Canon SERVICE MANUAL REPORT

Canon FD WIDE ANGLE Lenses Changes

Canon FD TELEPHOTO LENS Changes

Canon FD TELEPHOTO LENS 135mm 1:2.5, 100-200mm 1:5.6 Zoom Changes

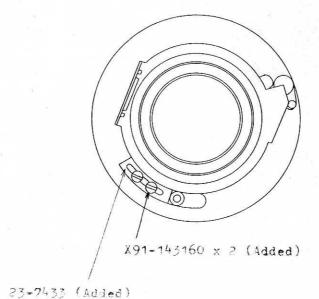
With the Cam Ping and the Diaphragm Rotor set fully open, the aperture leaf sometimes touches the bell crank. To prevent this a a stopper has been added. Its part number is 23-7433 and it is held by two screws (X91-143160).

The stopper cannot be installed on old lens barrels. Camera Service will stock only new lens barrels. The part number is not changed.

1. Bell Crank Friction Surface Change (FD 28mm 1:3.5, FD35mm 1:3.5 and FD 35mm 1:2.0)

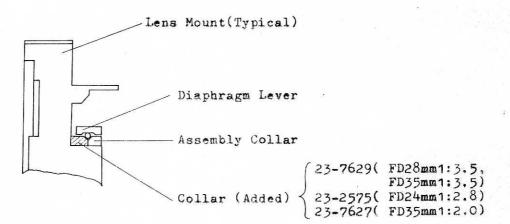
To insure smooth operation of the diaphragm, the bell crank friction surface on the lens barrel is now painted with a special baked-on dry lubricant paint.

- 2. Lens Mount
- 2.1 Lens Mount Change (FD24mm 1:2.8, FD28mm 1:3.5, FD35mm 1:3.5, FD35mm 1:2.0) To improve quality the following changes have been made to the lens mount. The shaded part shown in the drawing was originally part of the lens barrel. It is now a separate collar (See the drawing for the part numbers.). The plating of the Assembly Collar has also been changed from black nickel to nickel chrome.

Lens Mounts and Assembly Collars are interchangeable. The new collar must be used with the new lens mount.
